CRIME IMPACT STATEMENT

LAND OFF JURBY AVENUE, BLACKLEY, MANCHESTER
13 no. DEMENTIA CARE SUPPORTED LIVING APARTMENTS,
WITH ATTACHED COMMUNITY HUB

FOR: Irwell Valley Homes

REFERENCE: 2009/0928/CIS/02

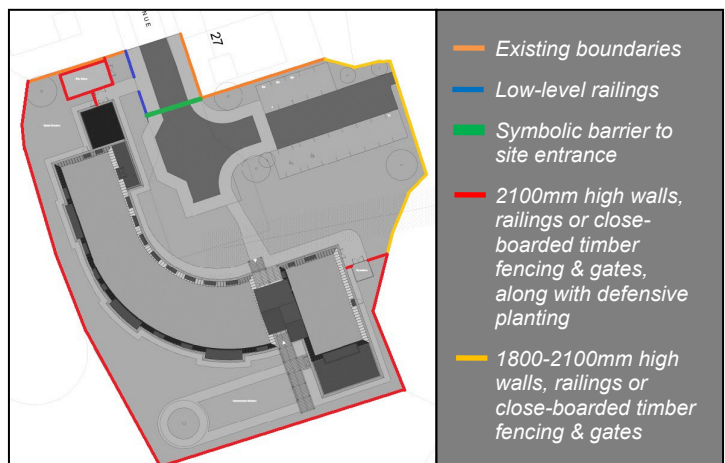
- 3.3.1 The landscaped areas to the sides and rear of the building should be securely enclosed as private space to prevent unauthorised access to hidden elevations of the building, where doors and windows may be vulnerable to unauthorised access unseen. Much of the rear boundary of the site will directly abut the existing open space to the south, east and west of the site. As such, the rear boundary of the site could be vulnerable to damage and unauthorised access unseen and must be particularly robustly defined to prevent damage, penetration and scaling (see illustration opposite and Section 4.5 for more information). If at all possible, it is highly recommended that low-level defensive planting (i.e.

low-level, densely branched, thorny shrubs) is provided on the public side of the perimeter fencing, to further deter access and scaling. Where this is absolutely unachievable, it could be provided on the private side of the boundary - although this is likely to be less effective. There should also be no publicly accessible trees/branches adjacent to the fencing, which could form a climbing aid.

- 3.3.2 Access into/around the building must be robustly controlled to prevent unauthorised access. The office adjacent to the main entrance should be staffed (at least during the day/peak visiting times) to ensure visitors are greeted and vetted before being allowed further access into the building. A high and wide reception desk will allow staff to have full surveillance of everyone entering and exiting the building and across publicly accessible external areas. If the entrance lobby is not to be staffed at any time of the day or night, the main entrance should be secured and should be capable of being controlled remotely by means of a video entry phone system linked to a staffed base/office, so that staff can vet callers to the building before allowing them access. If the community hub at ground floor level is to be accessible to/for the use of non-residents, it could provide anonymity to would-be criminals to access the rest of the building. It is therefore essential that if these communal facilities are intended for non-resident use, access between the community hub and the residential portions of the building must also be robustly controlled, to ensure that casual/unauthorised access between them is prevented. All internal back-of-house areas/staff facilities should be accessible to authorised staff only (see Section 4.1 for more information relating to access controls).

- 3.3.3 The secondary entrance to the community hub, located to the east of the main communal entrance, is recessed within a sheltered area underneath the first floor of the building, where it is partially hidden from the street and could potentially be attacked unseen. It is highly recommended that this entrance, if required, is brought forward to remove the hidden/sheltered space and maximise surveillance opportunities from Jurby Avenue.

- 3.3.4 The frontage of the site and the car park should be defined as entirely separate from the street, in ownership/control of the home. There should also be a symbolic barrier at the vehicular entrance to the site (e.g. brick pillars, change of road surface texture/colour etc.) to encourage a feeling of territoriality among the staff and residents, psychologically giving the impression that the area beyond is private and discouraging anyone without a legitimate reason from entering (see illustration above & Section 4.5 for more information). The parking areas should also be clearly signed as for the use of staff/residents/visitors only.
